Subject: Contract No. DE-AC06-93RL12367
**ELIMINATION OF ADMINISTRATIVE TECHNICAL SAFETY REQUIREMENTS ON EF-8 FAN AND HIGH EFFICIENCY PARTICULATE AIR FILTERS IN THE REDUCTION OXIDATION BUILDING**

**UNREVIEWED SAFETY QUESTION SAFETY EVALUATION FORM**
**PU LOADOUT HOOD STABILIZATION**
**DIS #: 0200W-US-N0156-02, Rev. 2***

**UNREVIEWED SAFETY QUESTION SAFETY EVALUATION FORM**
**PU LOADOUT HOOD STABILIZATION**
**DIS #: 0200W-US-N0156-02, Rev. 2**

EF-8 HEPA BANK
NORTH Sample Gallery

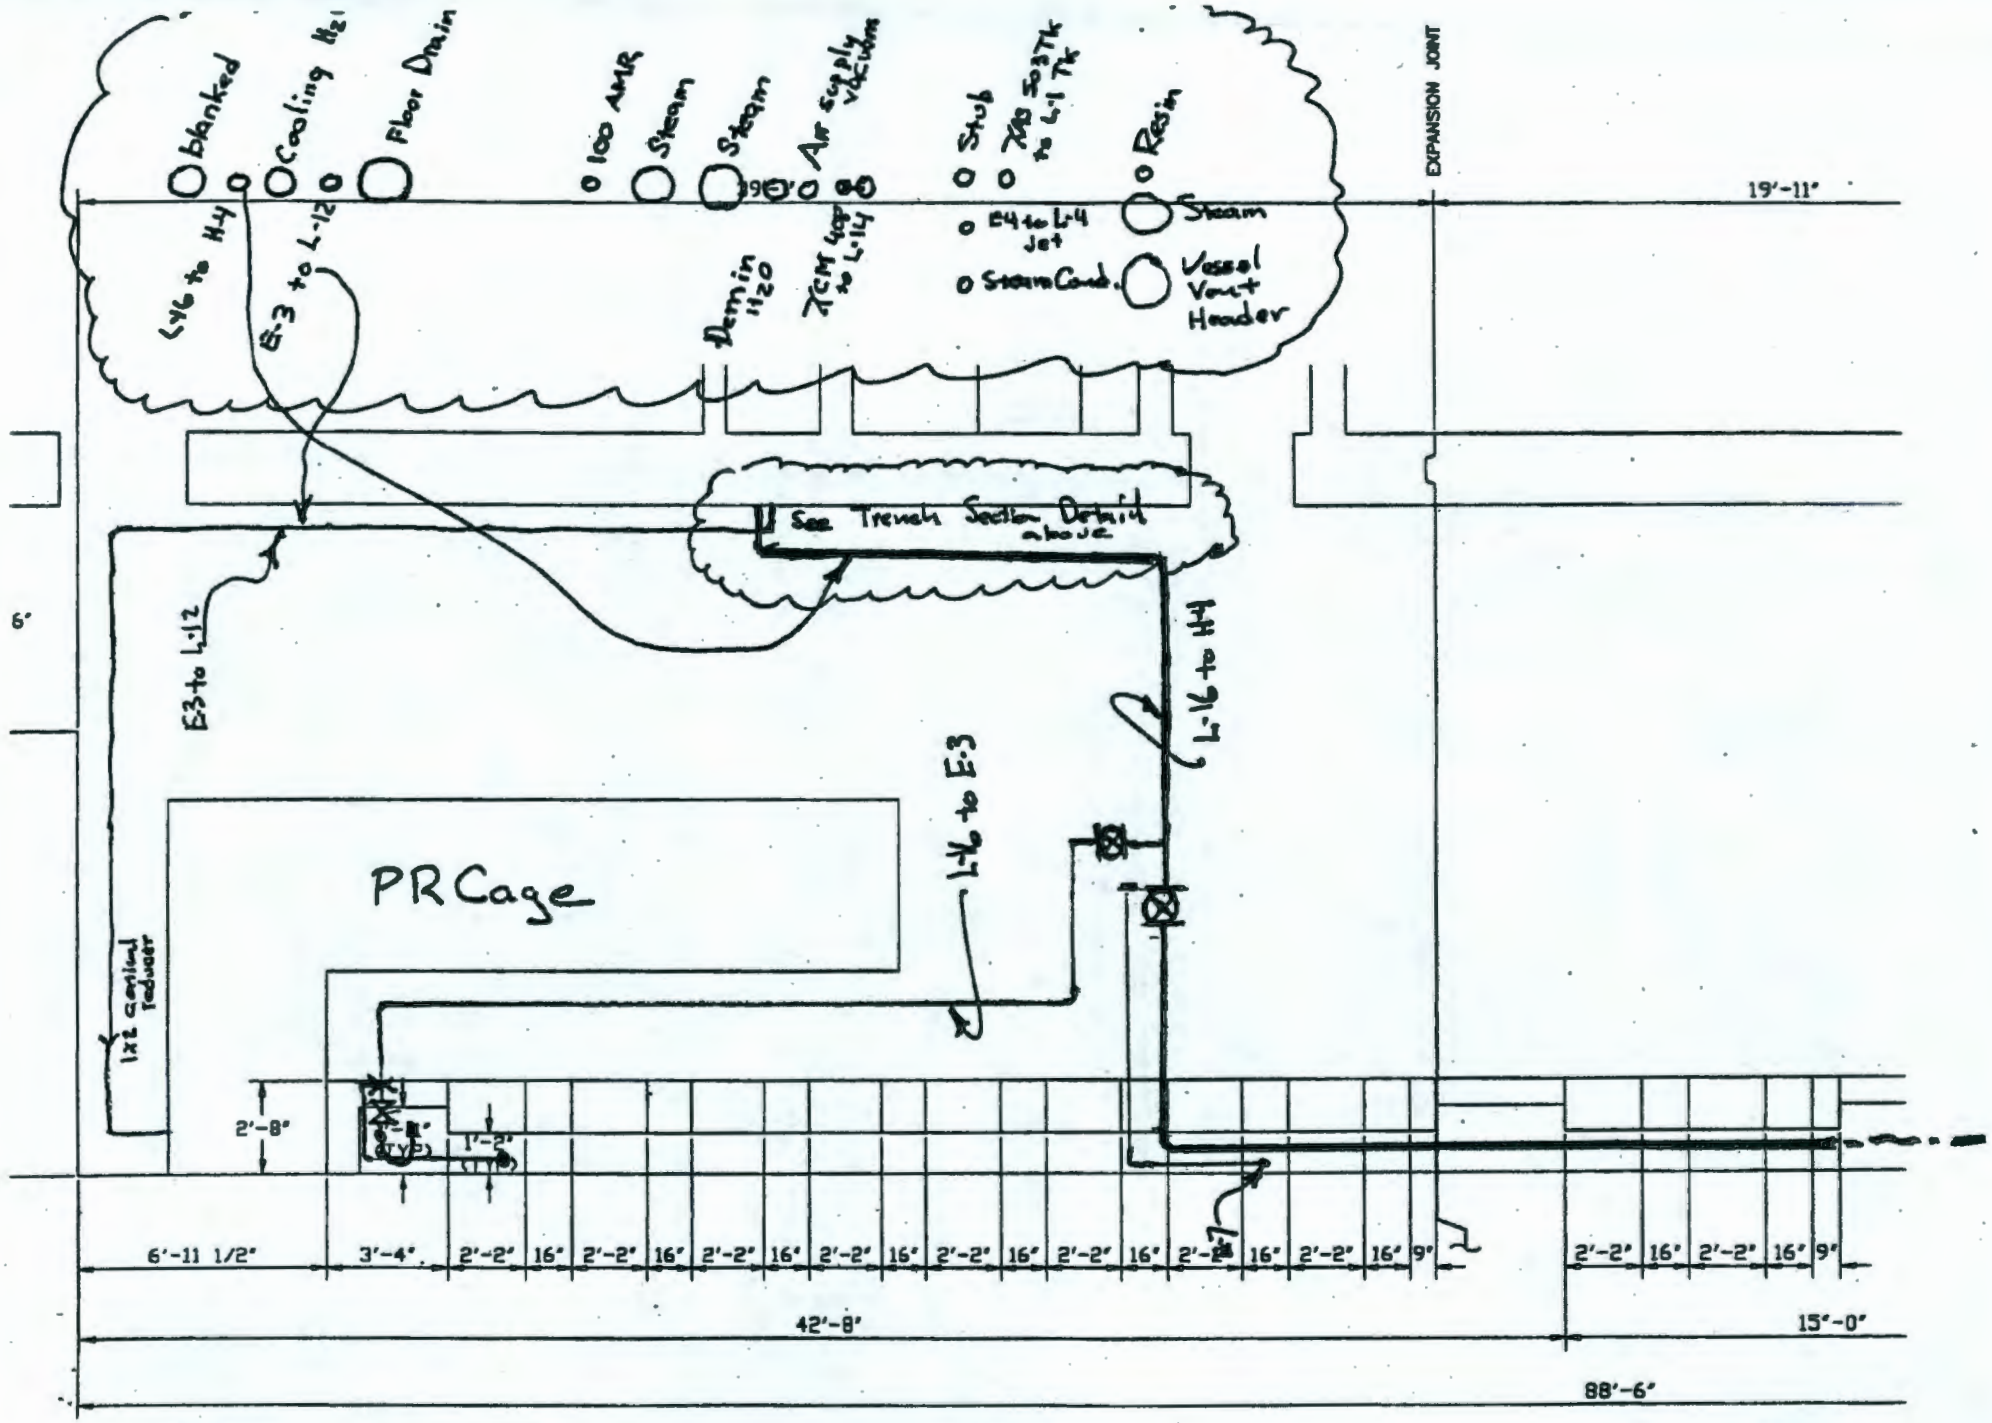
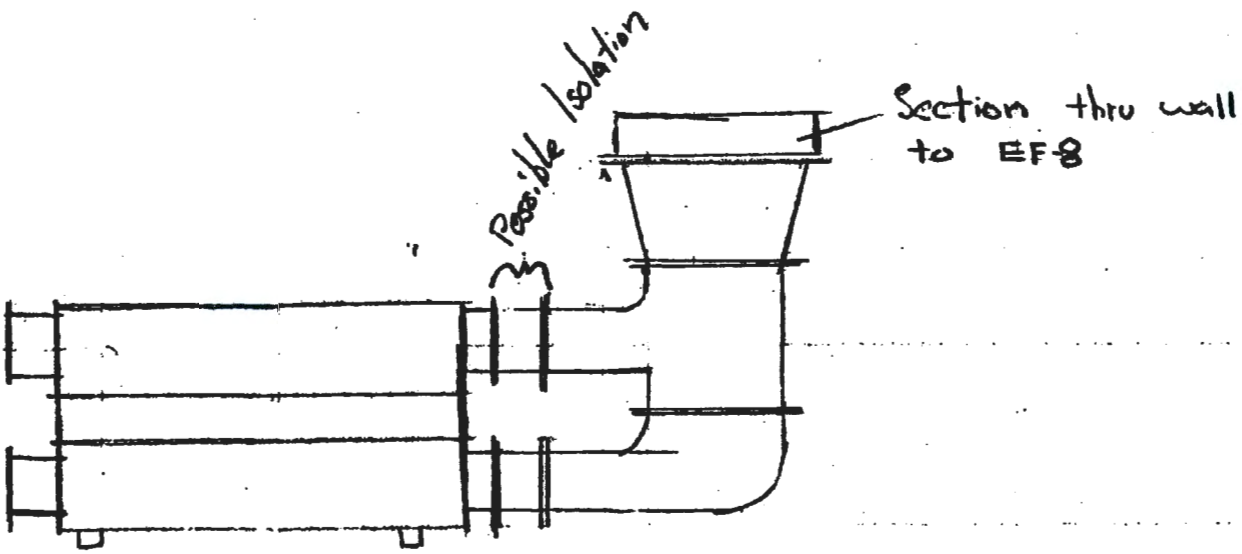
Assume: 1) Cap over 296-S-2
2) Isolate EF-8 duct on outside transition
